Recall Campaign

December 2017
FL743AB
NHTSA #17V-453 School Buses
#17V-454 Non School Buses
Transport Canada #17-359

Subject: TBB Wheelchair Pocket Track

Models Affected: Specific Thomas Built Buses Saf-T-Liner C2 school buses and non-school buses manufactured December 1, 2004, through May 30, 2017.

Figure 1: Drilling Locations

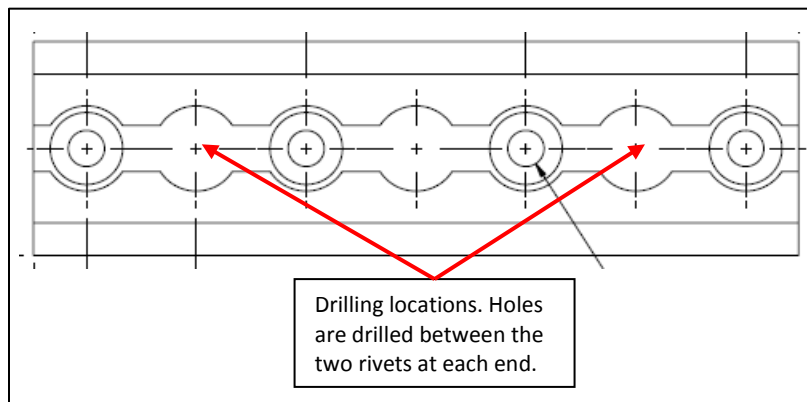
On certain buses, the wheelchair pocket track may not meet the anchorage requirement. This may increase the risk of injury in the event of a crash.

Additional fasteners will be added to the wheelchair pocket track to reinforce the anchorage.

1. Park the vehicle, shut down the engine, make sure the shifter is in Park or Neutral. Chock the tires.
2. Identify track locations and prepare the area for installation of the bolts. (Seats covering the track, preventing installation of the two bolts may need to be removed.)
3. Drill a hole through the track and the floor using a "P" bit (.3230 in. bit). See **Figure 1** for locations.

4. Create a countersink in each of the holes drilled. This should be an 82-degree countersink at a .191 in. depth.
5. Insert a 5/16 in.-18 X 1.25 flat head socket cap bolt (TBB 184059) in each hole.
6. Underneath the bus, install a washer (TBB 69004114) and nut (TBB 69004121) on each of the bolts inserted through the track and floor and tighten to 12-14 lbf.ft.

Figure 2: Bracket and Bolt

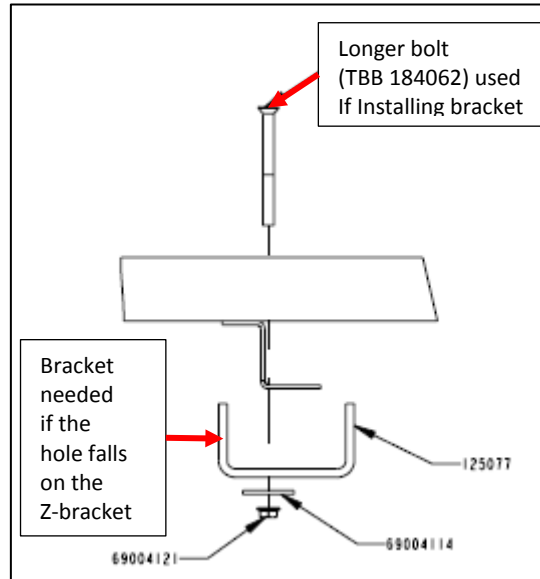
7. If the Z-section interferes with tightening the washer and nut against the floor, install a bracket (TBB125077) with a longer bolt (TBB 184062) over the Z-section as shown in **Figure 2**. If there is no interference, go to step 8.

NOTE: Use bolt TBB 184062 from the kit only when the Z-section interferes, otherwise it may be discarded.
See step 7.

8. Tighten each nut and bolt until secure against the floor and the bolt is flush against the top of the track.
9. Spray the new bolts with undercoating.
10. Repeat for each section of track.
11. Remove the chocks from the tires.
